TAB PUNCHLIST - Sep 19, 2024

L04358_Roseville FSU (MI)

32061 Gratiot Avenue, Roseville, Michigan

Sheet
M-701T

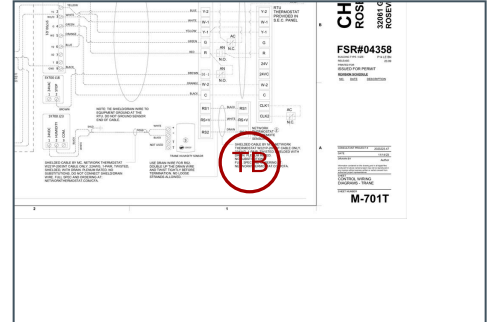
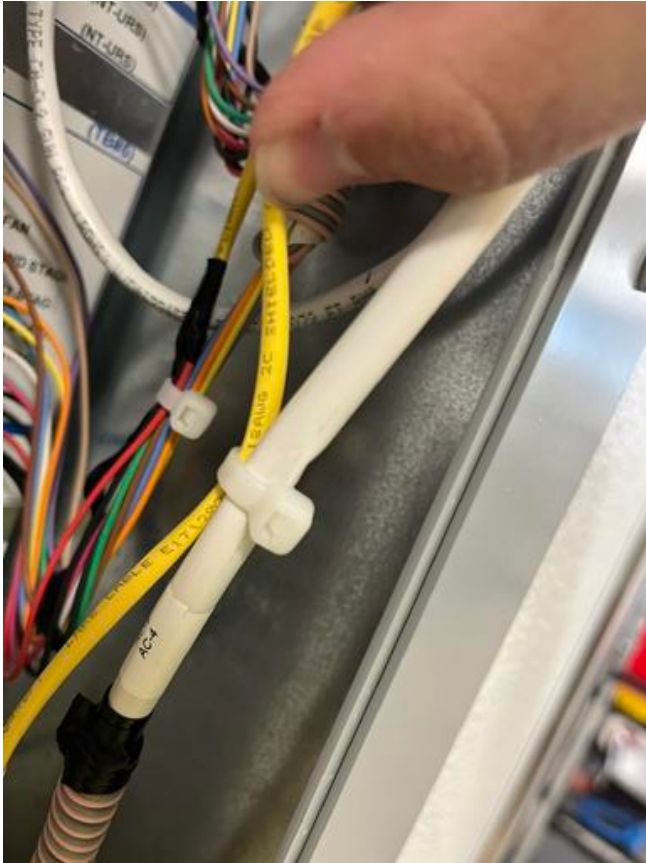
#82 [CNTL 003] [NEW] CRITICAL – Wiring specifications.

Description
Thermostat cabling is I not 18awg 12 conductor ConnectAir W1812C-2148 and / or sensor cable is not ConnectAir W221P-2003NT cable. Full spec and ordering at: NetworkThermostat.com/CFA

Sheet
M-501

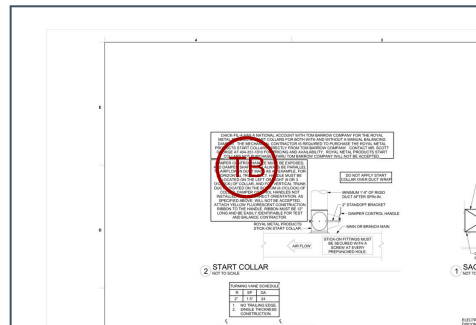
#81 [DUCT 008] [NEW] CRITICAL – Start collar damper orientation.

Dampers to be installed parallel to airflow. In horizontal runs, position damper on left or right at 9 or 3 o'clock. On vertical ducts position damper on bottom only (6 o'clock). Only found on one branch and branch is between two metal studs.

Sheet
M-501

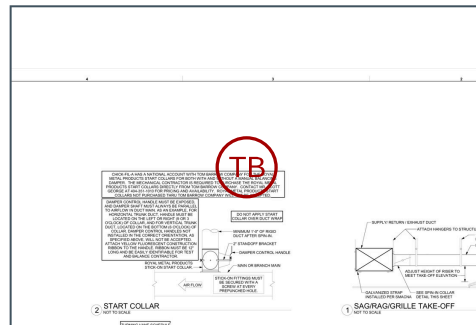
#80 [DUCT 009] [NEW] CRITICAL – Damper incorrect type.

Dampers observed of wrong type with incorrect standoff. Contact national account provider for replacements.

Sheet
M-503

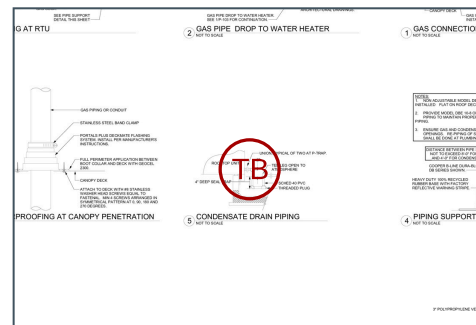
#79 [UNIT 517] [NEW] Condensate piping construction.

Equipment condensate piping or p-trap is not constructed per normal CFA specifications. It is causing excess condensation on the units.

Sheet
M-501

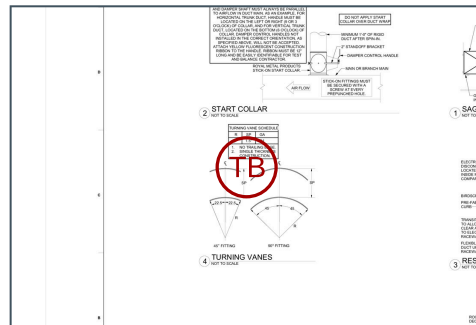
#75 [DUCT 001] [NEW] CRITICAL – Double thickness turning vanes.

Double thickness turning vanes are present in the system. Per specification only single thickness are to be installed in 90 degree turns where any dimension is greater than 12". Duct is not designed to accommodate the static drop across double thickness vanes. Remove and replace. Unable to balance system until corrected.

Sheet
M-101T

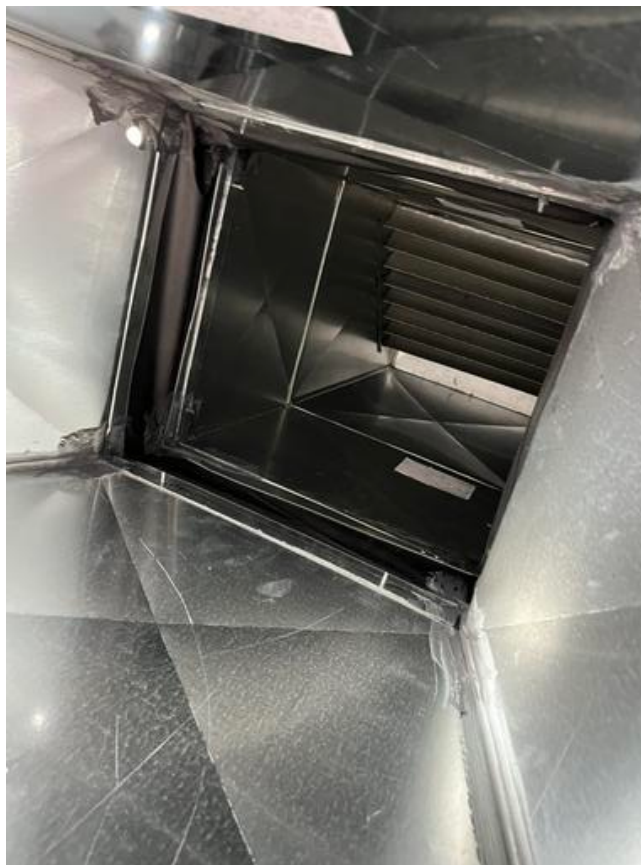
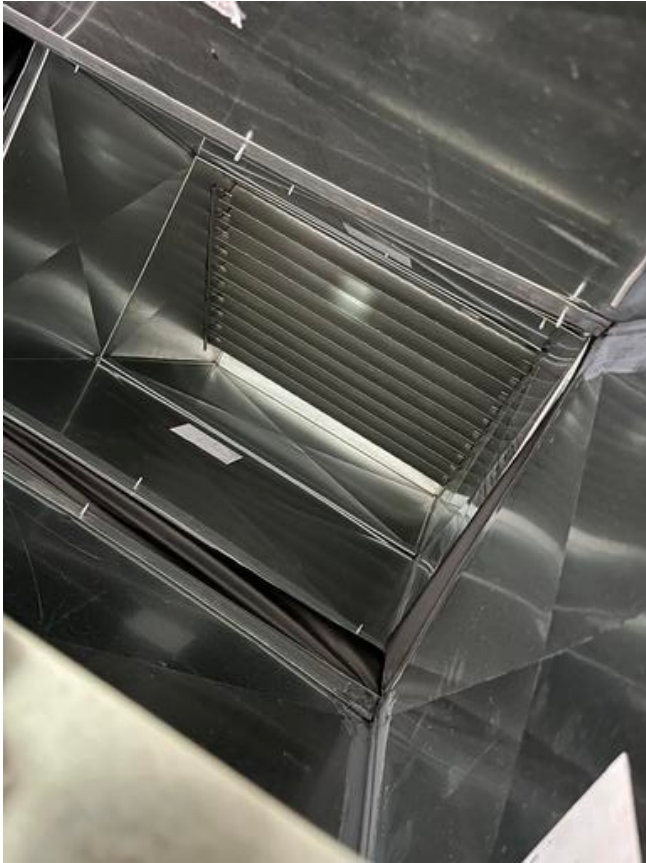
#74 [DUCT 002] [NEW] CRITICAL – Turning vanes in return duct.

Description
Turning vanes are present in the return duct and need to be removed per specification. Only present in returns for AC2, AC3, and AC4

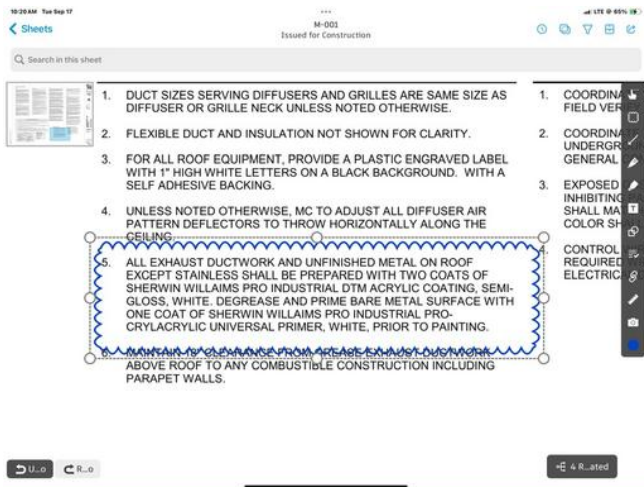
#68 [EXHA 509] [NEW] Grease exhaust duct is not painted.

Exposed grease exhaust duct is to be painted per specification on kitchen hood exhaust fan detail.

Currently the exhaust is stainless steel not requiring painting

According to M-001, Stainless steel does not get painted and the exhaust ductwork is stainless.

According to Bryan from Cushman, duct should still be painted as it is galvanized and not stainless.
